Group 6: Bit Bois

Project Assignment 12 - Design Changes After Walkthrough

02/21/23

Wireframe UI Changes:

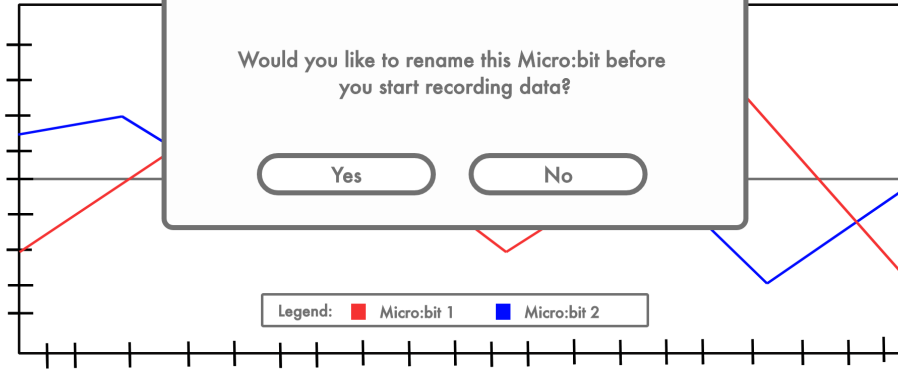
- The web bluetooth should handle connections, so an “error” response isn’t something we have to account for
 - *Accepted Change: No implementation change necessary*
- Change the connect dropdown to a button
 - *Changed: Reason - Doing it this way will play nicer with web bluetooth*
- Didn’t like the small resume/pause button
 - *Changed: Reason - The button is now bigger and less likely to be misclicked, this makes sense from a usability standpoint*

- *Accepted Change: Reason - Everyone is comfortable using React and there is lots of support libraries.*
- Didn’t like the check box for live data. Felt a pause/play button could be more intuitive.

- *Changed: Reason - This change makes the pause/play button easier for the user to understand.*
- List of implementation priorities:
 - Connection to MicroBit
